Change Bulletin				Tesco Corporation 5616 – 80th Avenue SE Calgary, Alberta, Canada T2C 4N5 Tel: 1-877-TESCO-77 (North America) Tel: 1 (713) 359-7195 (AMSS 24-hour support) Tel: 1 (713) 359-7295 (International) Email: bulletins@tescocorp.com www.tescocorp.com www.tescoparts.com
No: CB049	Rev: 0	Date: June 13, 2012		
Steel Cable Tugger Line to Replace Cat Line Tugger During Top Drive Rig Up

Figure 1: Using a steel cable tugger line in place of cat line tugger

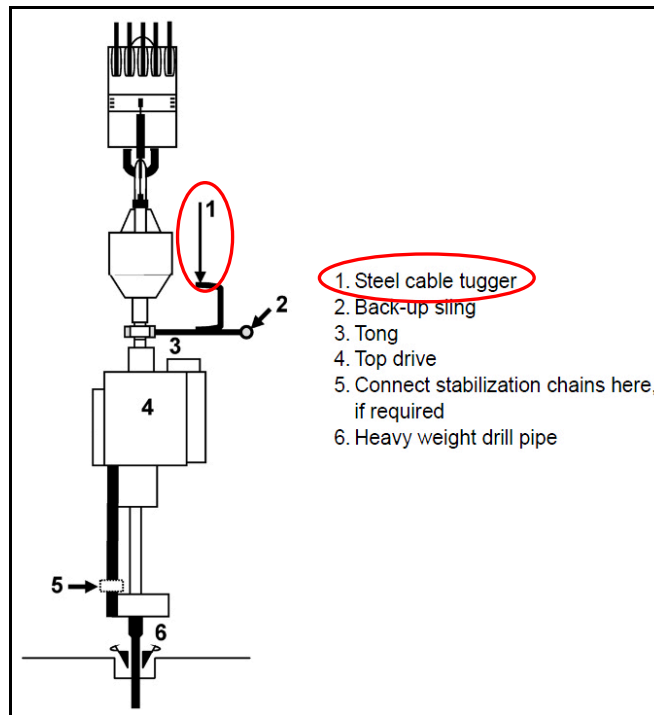
The rig up procedure in the TESCO Top Drive User Installation Guides includes a note to make use of a "cat line tugger" with rope to assist with installing the Top Drive. Top Drive rentals recently had a technician get hurt from using a cat line tugger that broke and dropped a torque bushing on the technician. Therefore Top Drive rentals is mandating that no cat line tuggers with rope be used when installing Top Drives on any rig; instead, they are to be replaced with a tugger line that uses a steel cable. References to cat line tugger on all Top Drive User Installation Guides need to be changed to suggest the use of a "tugger line".

All TESCO Top Drives that are operating in the field or are in the process of being rigged up must replace the cat line tugger with a steel cable tugger line.
